Facility: Arkansas Nuclear One, Unit 1

SUBJECT: MEETING WITH ENTERGY OPERATIONS, INC. (ENTERGY), ON LICENSE RENEWAL FIRE PROTECTION SCOPING FOR ARKANSAS NUCLEAR ONE (ANO), UNIT 1

# ANO-1 License Renewal

Fire Protection Open Item

FIGURE 60-02: FIRE WATER PUMPS

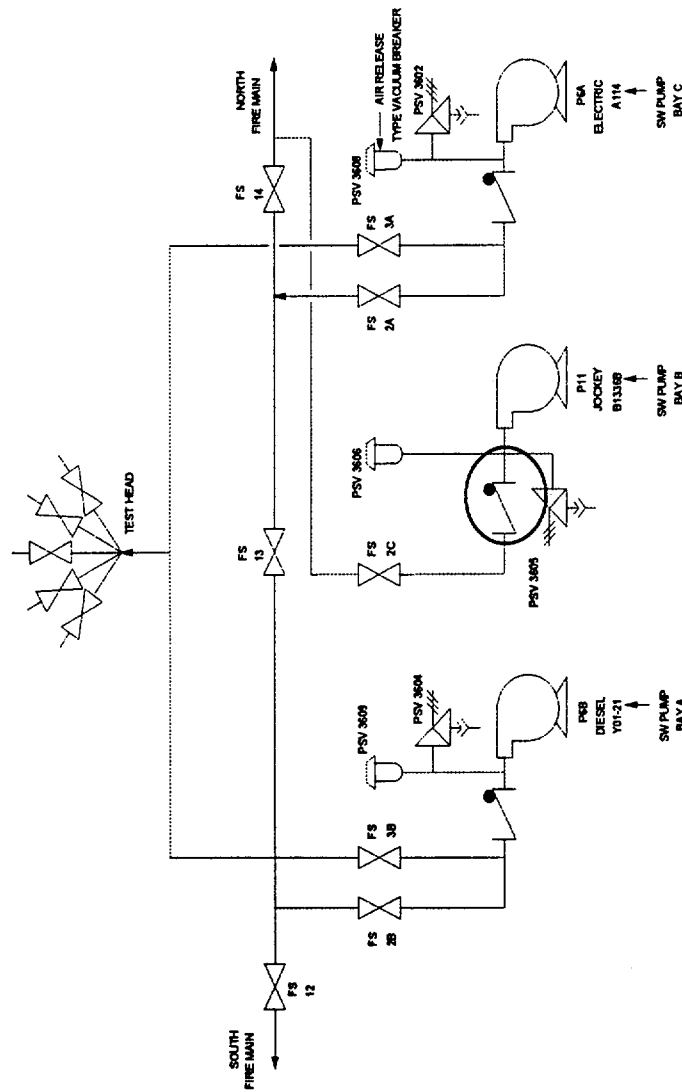
- ◆ Maintains fire main pressure when there is no demand on system
- ◆ Per BTP APSCB 9.5-1, “Details of fire pump installation should as a minimum conform to NFPA 20”
- ◆ Not a required component per NFPA 20 “Standard for the Installation of Stationary Pumps for Fire Protection”

- ◆ “Two vertical shaft centrifugal fire pumps are provided...”
- ◆ “An automatic electric jockey pump maintains pressure on the fire piping system.”
